Stair flip study · the main stair turned round: start and arrival at the NORTH end, next to the lift · Taif / Palm House V8.0 (work) · STUDY ONLY

ADOPTED 2 Nov 2026 (owner): option B, the freed landing as F-b, the balustrade, the store door onto the riwaq, the half-landing window, the entrance side light, the entry cupboard removed; applied to the design files. Owner's idea, 1 Nov 2026 · the same well (2.75 × 5.7 on axes, 2.525 × 5.50 clear), the same 22 risers × 0.164 / goings 0.28, flights 1.21 clear · nothing in the design files changes until the owner decides · all sizes assumed

1 · The two options on the ground floor

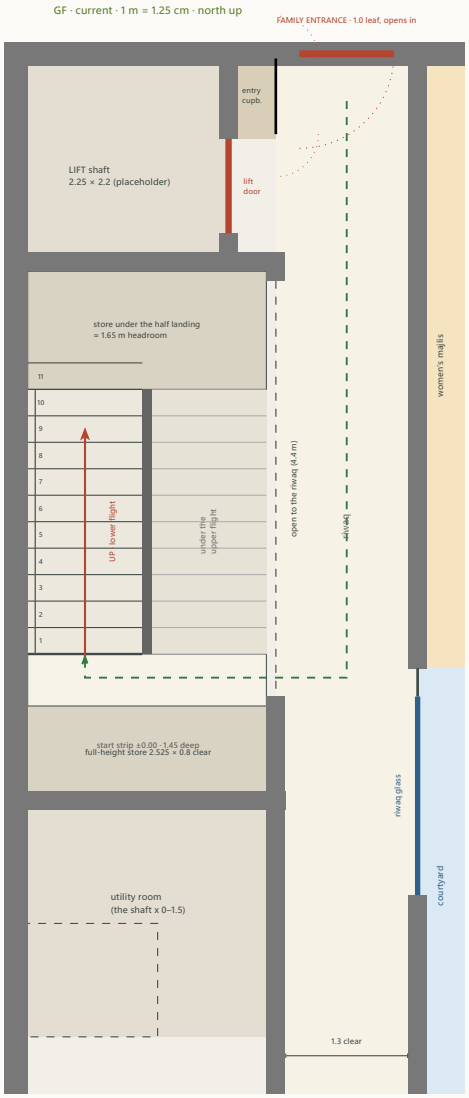
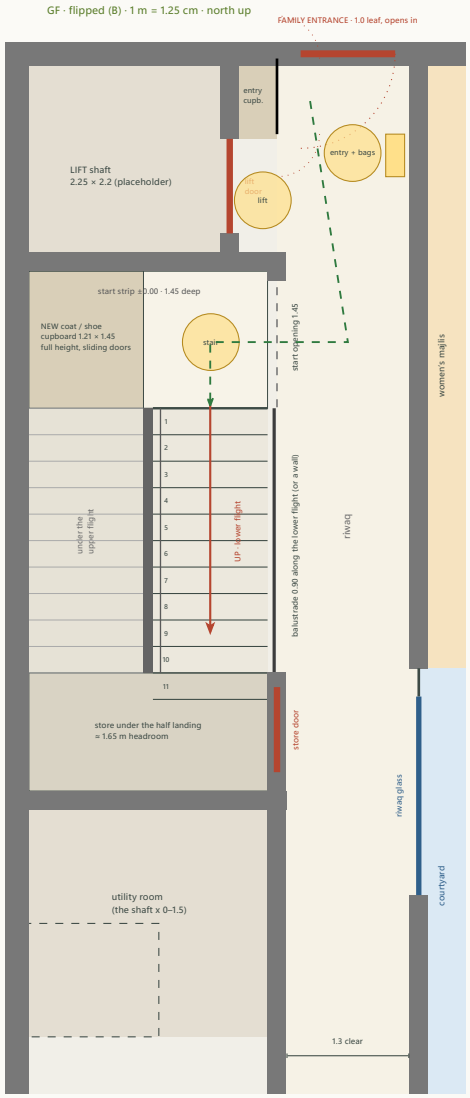
- **Current:** the lower flight on the **west** half starts at the **south** end (first riser y 6.35); the person comes along the riwaq, enters the well through its open east side (4.4 m open) and turns west onto the flight; in front of the first riser only **0.55 m** before the full-height store's wall (the start is really made from the side, under the upper flight's high end). Half landing at the north end (+1.80, a 1.65 m store below it, opening east onto the riwaq); the full-height store 2.525 × 0.8 clear at the south end.

- **Flipped (B, recommended of the two flips):** the lower flight on the **east** half starts at the **north** end (first riser y 3.75), **straight off the lobby**: a 1.45 m opening in the x 2.75 line between the lift notch and the flight, a start strip 1.45 m deep in front of the first riser. The lower flight rises along the riwaq side (a 0.90 balustrade on the riwaq, or a wall: the owner's choice); the half landing at the south end with its 1.65 m store (door onto the riwaq at y 6.7–7.6, in front of the courtyard glass; or into the utility room). The **west half of the start strip** (1.21 × 1.45, full height) becomes a **coat / shoe cupboard** beside the family entrance (sliding doors onto the strip).

- **Flipped (A):** the mirror image only (the lower flight stays west): the person crosses the whole strip to the far half before climbing; no cupboard. Not recommended; everything else below holds for both.

2 · Congestion test at the flipped start (drawn)

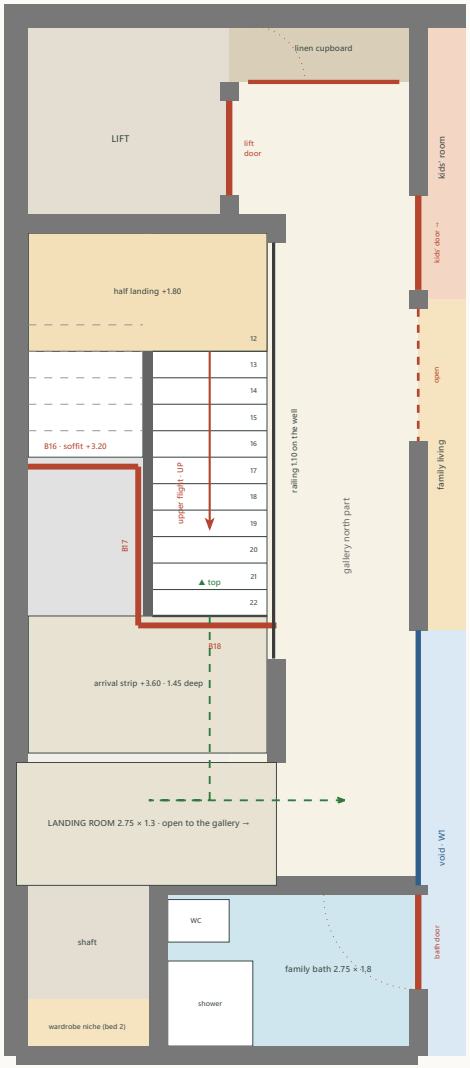
Three people at once: **one waiting for the lift** in the 0.50 m notch in front of its sliding door, **one coming in with bags** inside the family entrance's 1.0 m swing, **one starting up the stair** on the start strip, with the **entry cupboard's two 0.45 leaves open** into the lobby. Clear widths, not axes: the lobby **1.3 m** between the lift / cupboard wall face and the women's majlis wall face (the notch adds 0.5 m at y 0.9–2.2); the start opening **1.45 m**; the first riser **1.21 m** wide; the entrance **0.9 m** clear. The three stand in three separate zones along the lobby (y 0–1.0 the door swing, y 0.9–2.2 the lift notch, y 2.3–3.75 the start strip); the stair starter passes 0.3 m south of the lift waiter and never crosses the entrance swing: **OK**. Two people can pass in the 1.30 m lobby (0.60 + 0.60 + 0.10) but a person with two bags blocks it for a moment, as today. **Furniture up the stair:** the 90° turn from the 1.30 lobby through the 1.45 opening onto the 1.21 flight is a tight but normal house stair turn; the current start (0.55 m strip, sideways) is worse.

FF · current · 1 m = 1.25 cm · white = opening · grey = slab

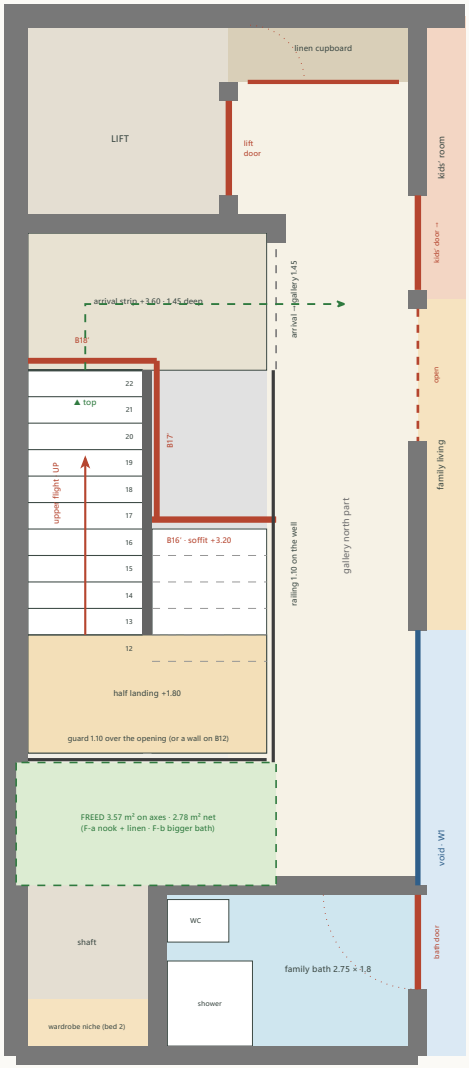
- **Current:** the upper flight (east half) lands at +3.60 on the arrival strip (y 6.35–7.8), then the **landing room** (2.75 × 1.3, y 7.9–9.2) and east into the gallery; the bedrooms and the family bath are at hand, the kids' room, the living and the lift are 6–9 m north along the gallery.

- **Flipped (B):** the upper flight (west half) lands on the arrival strip at the **north** end (y 2.3–3.75); the strip opens east onto the gallery's north part (1.45 m), **0.10 m south of the lift notch**: the lift's first-floor door, the linen cupboard (its leaves swing south, 0.6 m), the kids' room door (opens into the room) and the family living's opening are all within 1–3 m. The gallery's north part (1.30 clear) carries the arrival traffic as it carries the lift's today; the linen leaves and the lift door are 1.0 m north of the arrival: no clash. The railing on the well runs from the arrival (y 3.75) to the south wall; the landing room is **freed** (§ 5).

4 · The first-floor opening and its trimmers

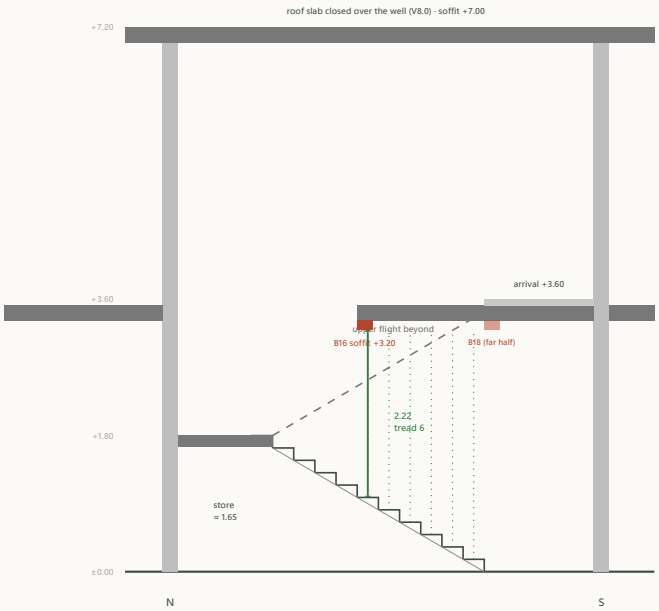
- **Current (studies/structure.typ):** an L-shaped opening ≈ 8.2 m²: the west half open from the north wall to B16 (y 4.85), the east half open to B18 (y 6.45); B16 (0.20 × 0.40, soffit +3.20) from the west wall to B17; B17 (x 1.29, on the lower flight's side of the split) from B16 to B18; B18 (y 6.45) from B17 to the riwaq-line beam B10 (x 2.75).

- **Flipped (B):** the **same opening turned round** (≈ 8.2 m²): the east half open from B16′ (y 5.33) to the south wall, the west half from B18′ (y 3.65) to the south wall. **B16′** (y 5.33) from the riwaq-line beam B10 to B17′; **B17′** (x 1.49, on the east, lower flight's side of the split: never over the upper flight) from B16′ to B18′; **B18′** (y 3.65, the arrival edge) from the west wall to B17′. The same zigzag, mirrored: one beam-on-beam junction at each end of B17′, the torsion the engineer's; B18′ now bears on the west wall (as B16 does today) and B16′ on B10 (as B18 does today). **Neither better nor worse** for the structure: the spans (1.3–1.6 m) and the bearings are the same kind. **Not verified.**

- **Slab edges:** the arrival strip (1.45 × 2.525) spans between the north wall beam B11 (y 2.2) and B18′; over the lower flight's first six treads the slab spans from B18′ to B16′ (1.6 m) between B10 and B17′. The guard round the opening: the railing on x 2.75 from the arrival south to y 7.9, the well's south wall line y 7.9 (a 1.10 guard or a wall on B12), the upper flight's balustrade on the split.

Headroom · a section along the lower flight for each option · the slab 0.2 thick (soffit +3.32), the trimmers 0.20 × 0.4 (soffit +3.20), the finish 0.08 · over the full walking width of every tread

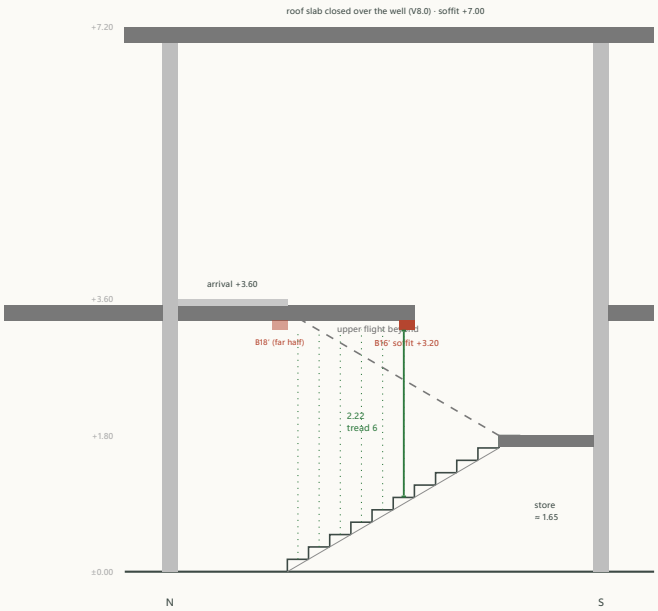
The upper flight, the half landing and the arrival are under the open well (the roof slab's soffit +7.00): ≥ 3.4 m. Minimum of this option: **2.22 m** at tread 6 under the trimmer, across the whole 1.21 m width (the trimmer spans the half); B17 over the inner 0.10 strip of treads 1–5: ≥ 2.38 m.

The upper flight, the half landing and the arrival are under the open well (the roof slab's soffit +7.00): ≥ 3.4 m. Minimum of this option: **2.22 m** at tread 6 under the trimmer, across the whole 1.21 m width (the trimmer spans the half); B17′ over the inner 0.10 strip of treads 1–5: ≥ 2.38 m.

Verdict on the headroom: identical in both options (**2.22 m** at tread 6 under the trimmer, 2.83 m at tread 3 under the slab; ≥ 2.10 required, the 2.20 aim just met) because the flip mirrors the geometry: the trimmers sit in the same places relative to the treads. **The flip neither improves nor worsens the trimmers.** What would improve both: trimmers 0.20 × **0.30** (soffit +3.30 → **2.32 m** at tread 6) if the engineer accepts a 0.30 depth for the 1.3–1.6 m spans, or the slab edge moved one tread (the opening 0.28 m longer, ≈ 0.35 m² more void, tread 6 under open sky → the minimum moves to tread 5: 2.38 m). Both options can take either. The walls' handrails run the full flights (0.08 off the walls); the central handrail on the 0.10 split.
